ADDENDUM No. 2

Project: 2018 Community Conservation Park

Chapel Lake Park

Date: November 12, 2018

Stream Restoration Quantities Estimates for Upper Lentzier Creek (11/01/18)

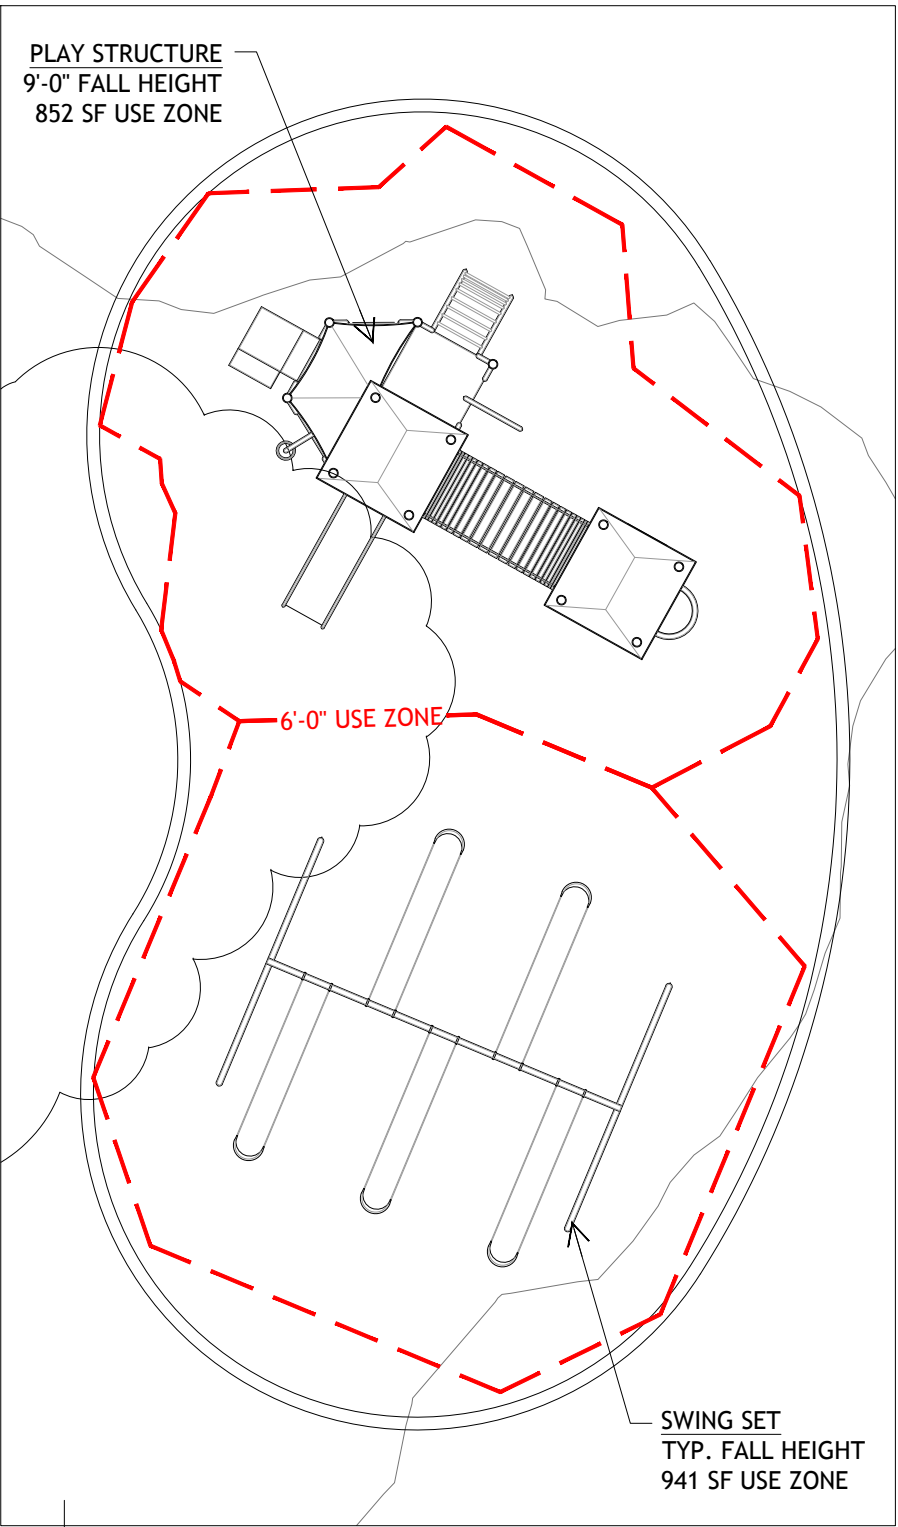
- Refer to the attached "Stream Restoration Quantity Estimates" document to use for a reference.
